## Evaluation of proposed move for Water Right Nos 3125 & 22922

Proposed: Move water right no. 3125 a distance of 2,604 ft to the northwest. Move water right no. 22922 to the well currently authorized under water right no. 3125.

## GMD3 Change Review

File No(s): 3125 & 22922.

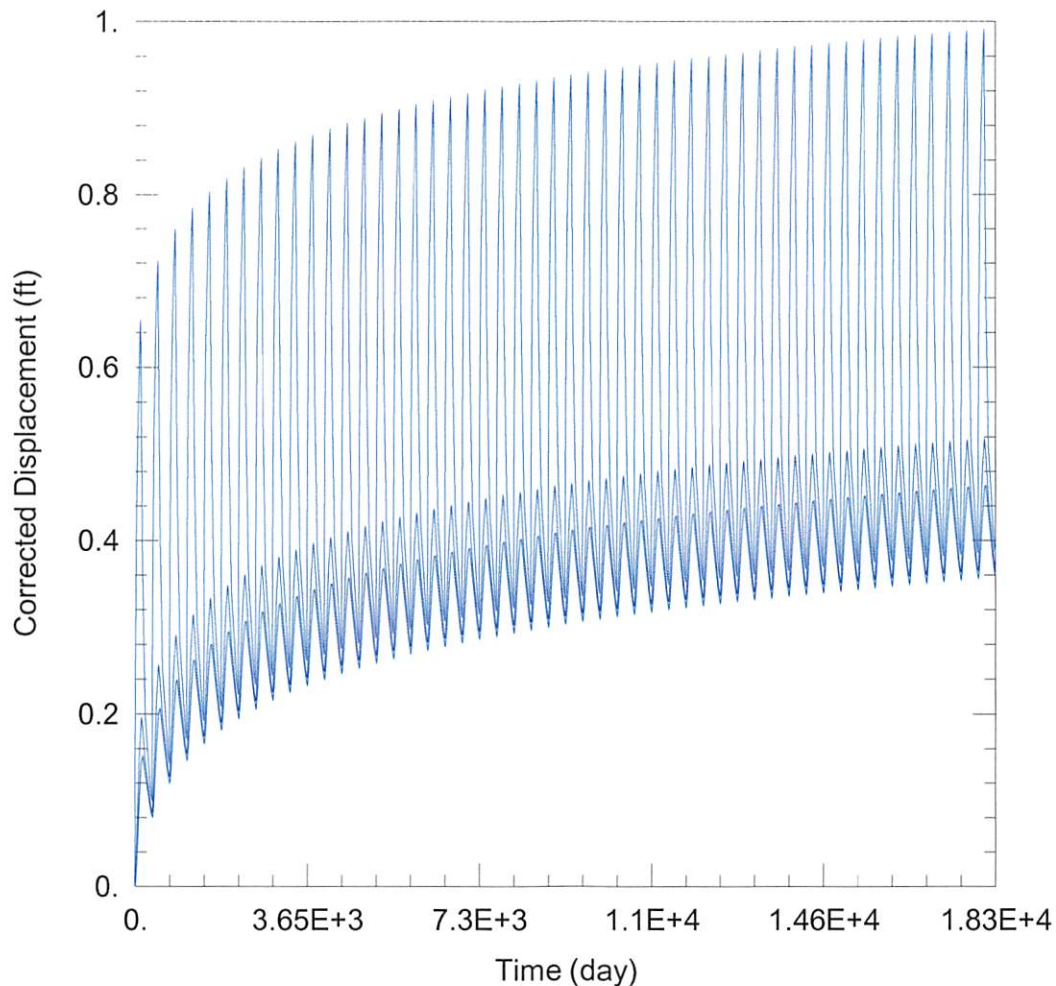
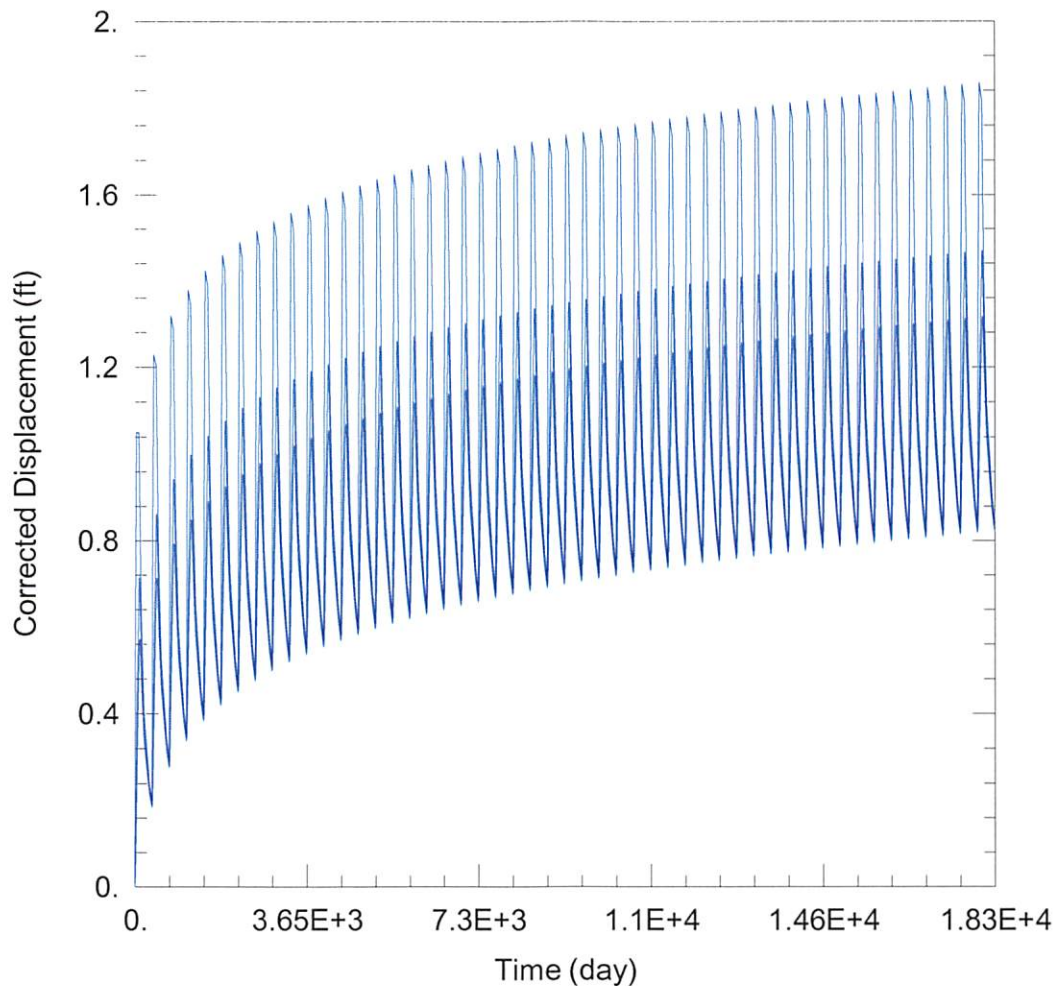
Theis drawdowns were calculated as follows:

Domestic 4-31-28:      Drawdown from current location = 0.46 ft  
                                 Drawdown from proposed location = 1.32 ft  
                                 Net drawdown = 0.9 ft

Domestic 9-31-28:      Drawdown from current location = 0.52 ft  
                                 Drawdown from proposed location = 1.47 ft  
                                 Net drawdown = **1.0 ft**

Domestic 10-31-28:      Drawdown from current location = 0.99 ft  
                                 Drawdown from proposed location = 1.86 ft  
                                 Net drawdown = **0.9 ft**

Net drawdown does not exceed the drawdown allowance of 4.0 ft for any well within 1 mile of the proposed location. Therefore, critical well analysis is not necessary.

The proposed move is likely to create minimal effects on neighboring wells and is unlikely to cause impairment. GMD3 staff recommends approval of this proposal.
